**February 24, 2017**

**The following were questions asked at the Pre-bid Conference held February 22, 2017:**

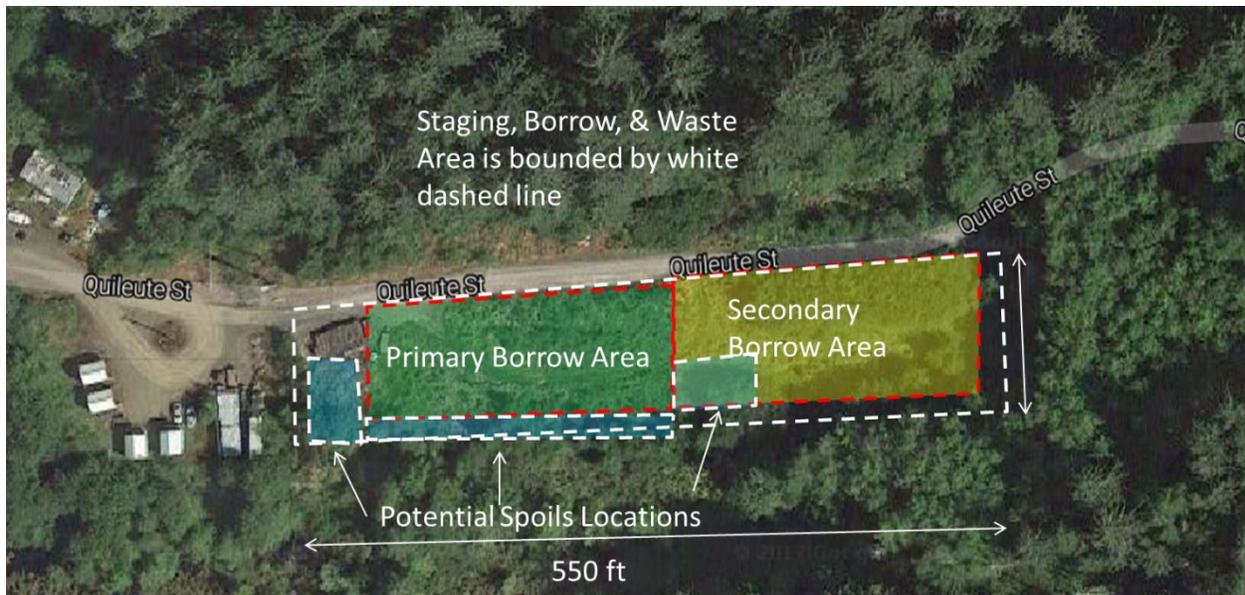
Q: What should be done with the organic spoils at the end of Thunder Road (turnaround portion)?

A: Contractor may spoil adjacent to the end of the road in cleared areas that shall be agreed on with the Owner. No trees shall be felled over 6 inches in diameter without Owner's consent. Spoils shall be placed in a manner similar to the detail shown on page 5 of 7 on the plans.

Revised New Construction Section Drawing

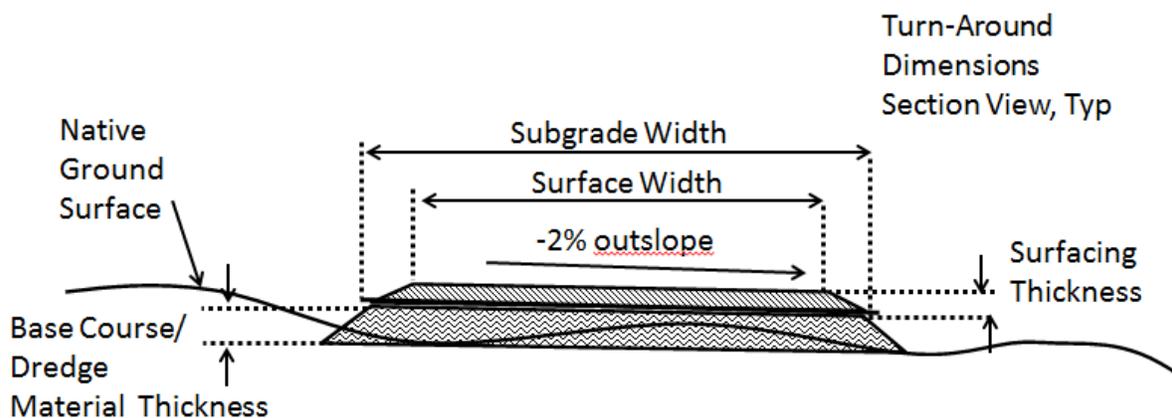
Q: Can the road be graded and rock on top?

A: Yes. Refer to Section 5 Road Work of the Road Plan. Areas with no to minor potholing need them filled and then the road graded – See Grading & Potholes. The portions of the road with significant potholes require that the holes be filled and then the road reshaped. Stretches of uneven (severely outsloped) road would be reshaped to match the provided detail on page 8 – See Reconstruction Work. Portions of the road with no base, Sta 56+50 to 65+50, would get 1ft of base/dredge material and then a crushed surfacing top course. - See New Construction Work. A surfacing thickness is not called on the road table. It should be 0.5ft deep. This crushed surfacing top course would be applied and compacted along the entire road length, 0+00 to 65+50.

Road Property	Measurement
Subgrade Fill (Only applies to New Construction)	1 ft
Surfacing Fill	0.5 ft
